**LAND OFF ROMSEY ROAD, WHITEPARISH,
SALISBURY, WILTSHIRE**

RESPONSE TO LLFA CONSULTATION RESPONSE

TSH/TN/0309/7191
2nd April 2026

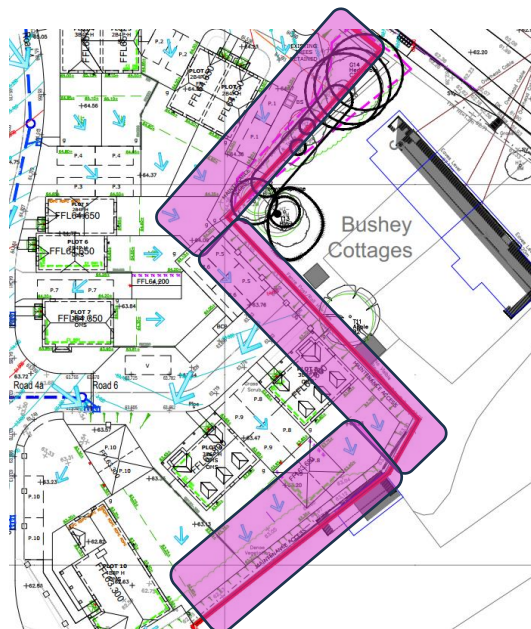
- While noting the applicant has provided a revised exceedance flow path drawing, updating exceedance flow routes notably around plots 17-21 and 11-16, further details are required.

Despite the example section of the retaining wall, the impact of retaining walls on surface water flows is still unclear, particularly whether surface water may be dammed.

To demonstrate that surface water exceedance will be safely managed, the applicant must add hatching to the exceedance drawing to clarify where pooling will occur onsite during the 1 in 100+CC event, particularly adjacent to retaining walls (e.g. plot 11 & 16).

In addition, the applicant must clarify how exceedance flows are managed onsite, without increasing risk to adjacent people & property. Currently it is unclear on the eastern boundary (pink) whether flows will be contained and managed onsite, or directed over the boundary onto adjacent land.

Appendix B:
Proposed Levels and Exceedance Plan

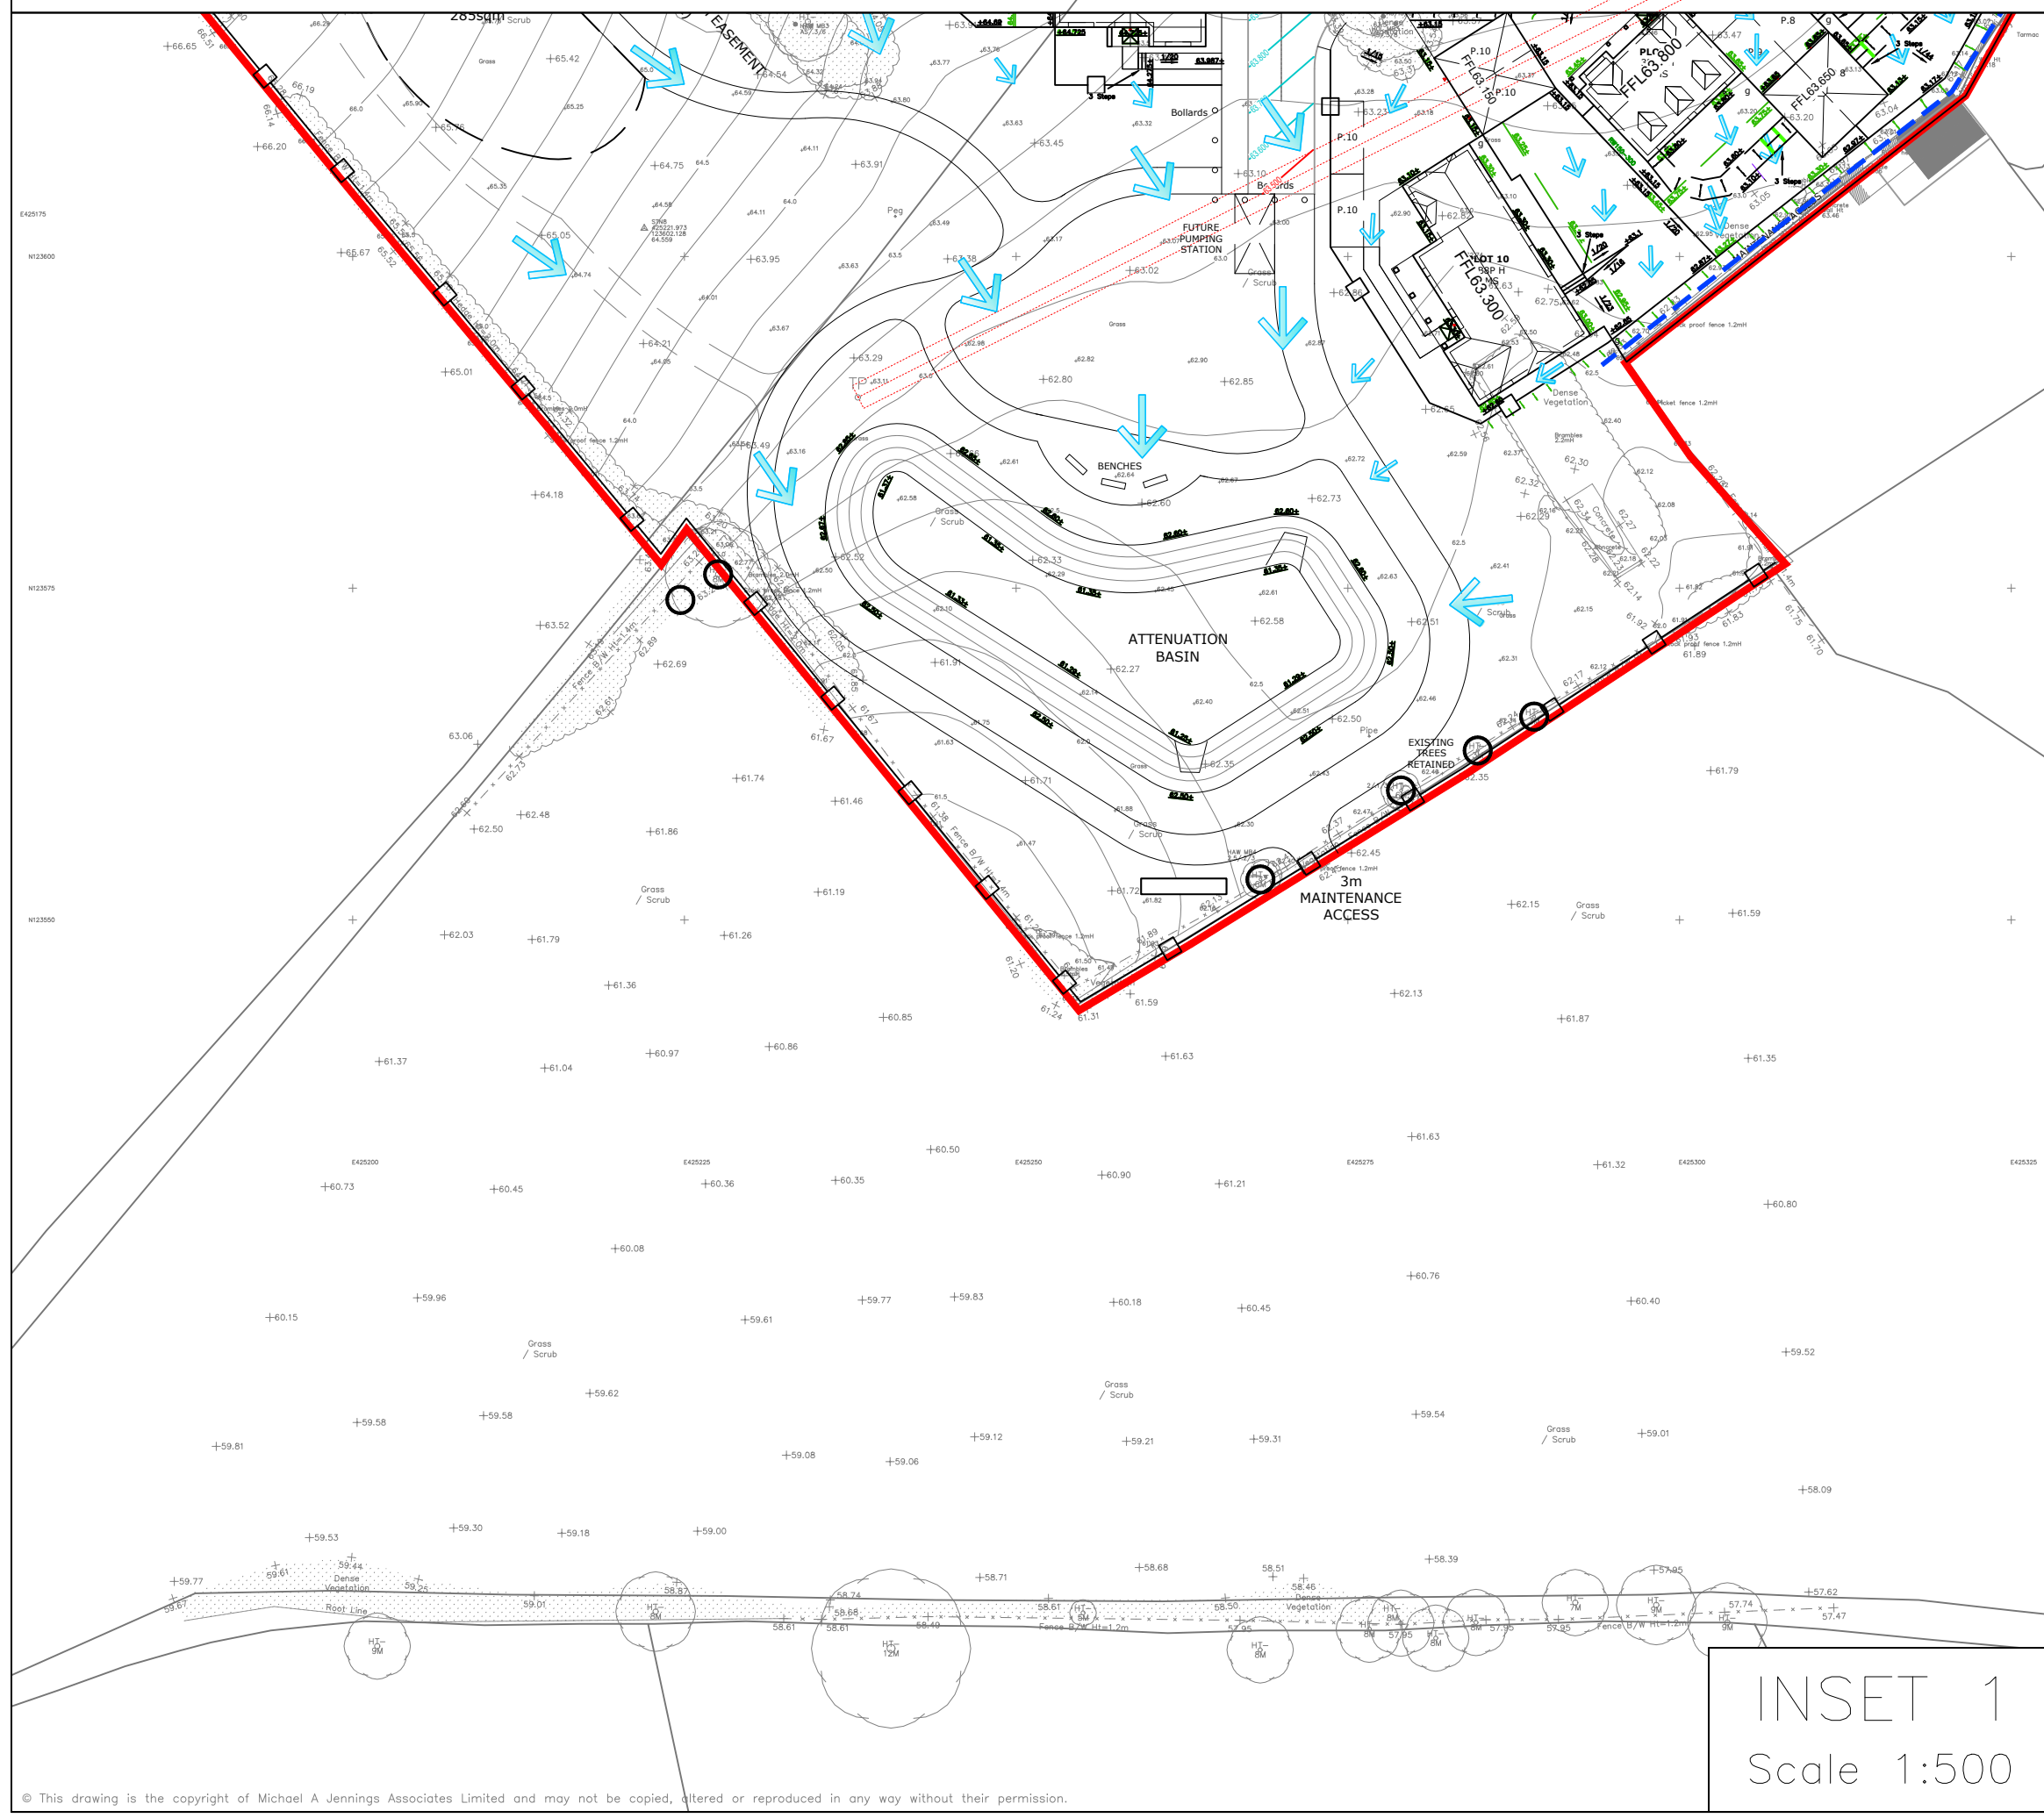
While noting the applicant has provided a revised exceedance flow path drawing, updating exceedance flow routes notably around plots 17-21 and 11-16, further details are required.

- *Despite the example section of the retaining wall the impact of retaining walls on surface water flows is still unclear, particularly whether surface water may be dammed.*
- *To demonstrate that surface water exceedance will be safely managed, the applicant must add hatching to the exceedance drawing to clarify where pooling will occur onsite during the 1 in 100+CC event, particularly adjacent to retaining walls (e.g. plot 11 & 16).*
- *In addition, the applicant must clarify how exceedance flows are managed on site, without increasing risk to adjacent people or property. Currently it is unclear on the eastern boundary whether flows will be contained and managed onsite, or directed over the boundary onto adjacent land.*

The proposed levels design for the site has been reviewed to reflect the comments made by the LLFA and provide further clarity and improvement on exceedance flow paths. Additional detail has been added around the houses and within gardens to demonstrate where water will flow to and to demonstrate there is no damming of flows against retaining walls, plots or garages.

The refinement of the design aimed to remove as many retaining walls as possible whilst providing suitable detail to enable a comprehensive review of exceedance flow paths. Where the removal of retaining walls led to steeper gardens, to a point where Bargate felt the space would be unusable, rollovers have been utilised with steps and timber sleeper walls providing a tiered garden with usable space on the high and low side. The revised levels design has been included in **Appendix B**.

Based on the amended levels design pooling of water will not occur and therefore the requested plan has not been provided however a more detailed overland exceedance plan has been provided that relate to the new levels design described above. This shows that exceedance flows will not be dammed and therefore will not pool. All exceedance flow will be routed to the roads, public open space and the attenuation basin. Refer to **Appendix B**.

As described above the proposed levels design has been refined with further detail provided demonstrating the route of exceedance flows. On the eastern boundary the proposed levels do show exceedance routes flowing towards the boundary and existing properties beyond as they do in the existing scenario. However, to allay the concerns of the LLFA a cut off filter drain is proposed to intercept exceedance flows from the site and route them along the boundary towards the
